**Monks Orchard Residents'  
Association  
Planning**

Location: 81 The Glade, Croydon, CR0 7QN, ,

Application Number: 21/00108/FUL

Appeal Ref: APP/L5240/W/21/3286648

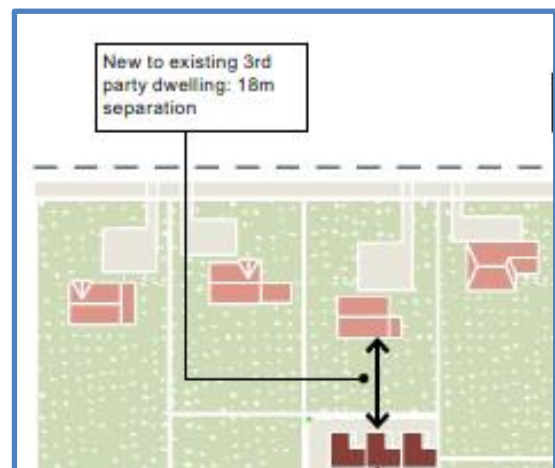
- 2.1.3 The Impact on the street scene from Lorne Gardens and the adjacent dwelling, South facing Elevations Impact negatively, (Street Scene) as viewed from Lorne Gardens, showing the height difference and separation between the proposal at **81 The Glade** and **79 Lorne Gardens**.

- 2.1.4 The overbearing height is approximately **~4m** above the height of dwellings in Lorne Gardens and only **~13.5m** distant from the actual adjacent dwelling (as scaled off the supplied Drawings). **SPD2 at Figure 2.9f** requires a minimum of **18m** separation between existing and new developments.

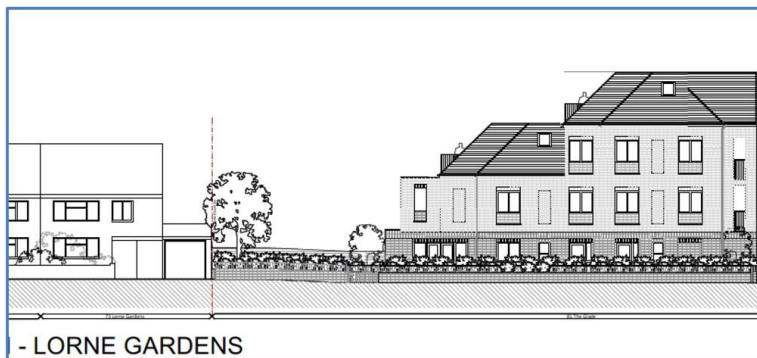
- 2.1.6 We have already proved the Massing is unacceptable and the height of the proposed development is **4 storeys**. Therefore, the height as perceived from Lorne Gardens fails the **SPD2 guidance** of one additional storey to that of the existing adjacent dwellings which are all **2 storey** dwellings. As the massing is not responsive to neighbouring properties (also see later SPD2 para 2.11), the corner height fails the policy SPD2 para 2.14.2.

2.1.7 We offer the following illustrations which would overcome the issues of overbearing and provide the full height fronting the Glade where a reduced height fronting Lorne Gardens would be much more acceptable. **However, this would NOT resolve the failure to meet the 45-Degree Rule toward the rear (Westward rear Elevation) of 83 The Glade (See later).**

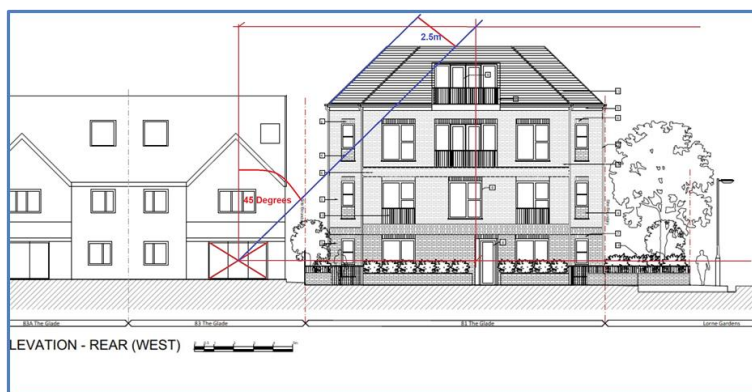
- It follows the **45 degrees rule demonstrated in Figure 2.11b and 2.11c**. In exceptional circumstances, where orientation, topography, landscaping and neighbouring land uses allow, there may be scope for a depth beyond **45 degrees**.*
- The flank wall is designed to minimise visual intrusion where visible from neighbouring properties"*

2.1.9 As there are NO mitigating circumstances, i.e., where orientation, topography, landscaping and neighbouring land uses allow, there are NO circumstances whereby the **45-Degree Rule** should be relaxed. Therefore, the proposal **materially impacts** on the amenity of **83 The Glade** and fails to meet the **45-Degree SPD2**

**The Supplied Drawings Rear Elevation Illustration of 45-Degree Rule projection from Centre of Ground Floor Patio Door at 83 The Glade.**

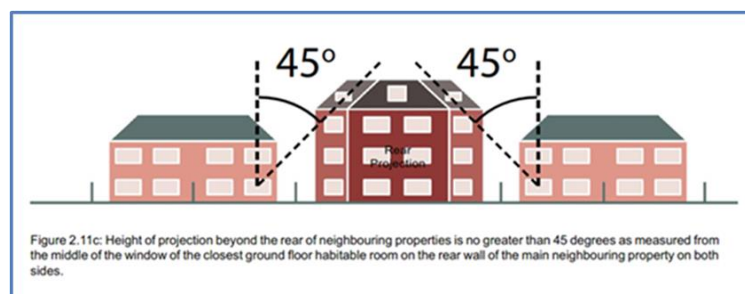
- 2.9 **Item 6.4 Bullet Point 9:** • "No daylight assessment has been provided to assess impacts on 83 The Glade. The south facing rear garden of **83 The Glade** will be in virtual constant shade and the new building will be overbearing. 45°degree projection lines are breached from number 83."

- 2.9.1 The proposed development would cast shadows over the rear garden of 83 The Glade for most of daylight hours as the proposed development would be about 3m higher than 83 The Glade and would also fail the 45-Degree Rule by about 2.5m intersect of the projection.

**Extract from Table 10.3 - Maximum Residential Parking Standards**

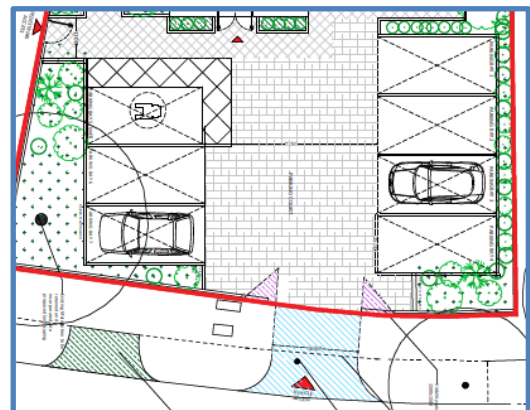
- 2.13.3 The allocation of only **7** spaces for a likely occupation of **18 adults** is under provision by at least 7 bays (~50%) and will result in overspill which would require on-street parking normally overnight. This overspill is likely to be in Lorne Gardens.

- 2.13.4 Given the “**modest**” forecourt area, as acknowledged in the applicant’s “Addendum” it would be appropriate to have provided **swept path illustrations** for ingress and egress when all other bays are occupied. This is appropriate specifically for Bays with **minimum lateral space** i.e., nearest to the building, as there would be very restricted steering lock possible for an exit manoeuvre from that bay. These practicalities have not been considered by the **Case Officer**.
